Access Compliance Report

Public Rights-of-Way

(Curb Ramps)

Intersection ID: 30007	Main Street: DUNBERRY_CT	Cross Street: OAKBORO_LN	Location: NW
ADA ID: CCACAB965BAB	Ramp Type: BlendTrans2	Initial Pass/Fail: Fail	Overall Compliance: No
		Severity Score: 25

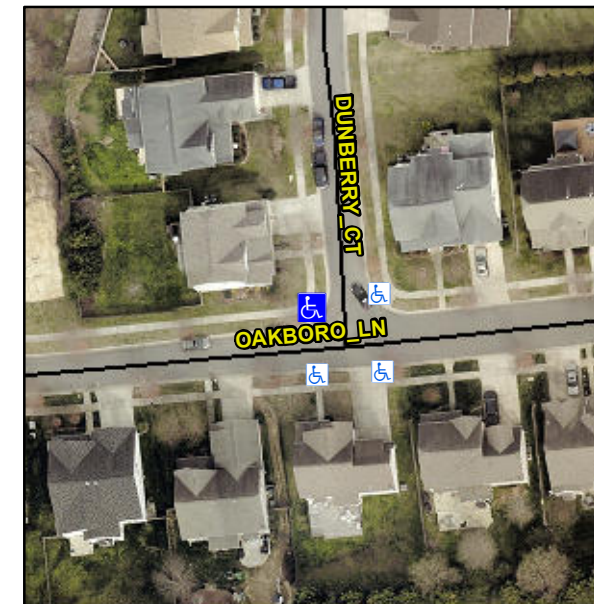
Not Found, R304.5.3

Compliance	Description	Data	Compliance	Description	Data
N/A	Ramp Length (in)	72.5	Yes	BlendTrans Slope (%)	3.0
Yes	Ramp Width (in)	48.0	No	BlendTrans XSlope (%)	13.7
N/A	Flare Type LT	N/A	N/A	Flare Type RT	N/A
N/A	Flare Slope LT (%)	N/A	N/A	Flare Slope RT (%)	N/A
N/A	Flare Traversable LT?	N/A	N/A	Flare Traversable RT?	N/A
N/A	Landing Length (in)	N/A	N/A	DWS Provided?	N/A
N/A	Landing Width (in)	N/A	N/A	DWS Contrast?	N/A
N/A	Landing Slope (%)	N/A	N/A	DWS Length (in)	N/A
N/A	Landing X Slope (%)	N/A	N/A	DWS Full Width?	N/A
N/A	Landing Curb? (Y/N)	N/A	N/A	DWS Offset (in)	N/A
N/A	Shared Landing?	N/A			
N/A	Gutter Ponding?	N/A	N/A	Gutter Slope (%)	N/A
N/A	Gutter Lip Ht (in)	N/A	N/A	Gutter X Slope (%)	N/A
N/A	Painted X Walk1?	No	N/A	Painted X Walk2?	No
	X Walk 1 Direction	To S		X Walk 2 Direction	To E
	X Walk 1 Width (in)	N/A		X Walk 2 Width (in)	N/A
	X Walk 1 Slope (%)	2.3		X Walk 2 Slope (%)	7.7
	X Walk 1 X Slope (%)	10.5		X Walk 2 X Slope (%)	3.2

Remove & Replace Curb Ramp With Two New Directional Ramps or Equivalent.
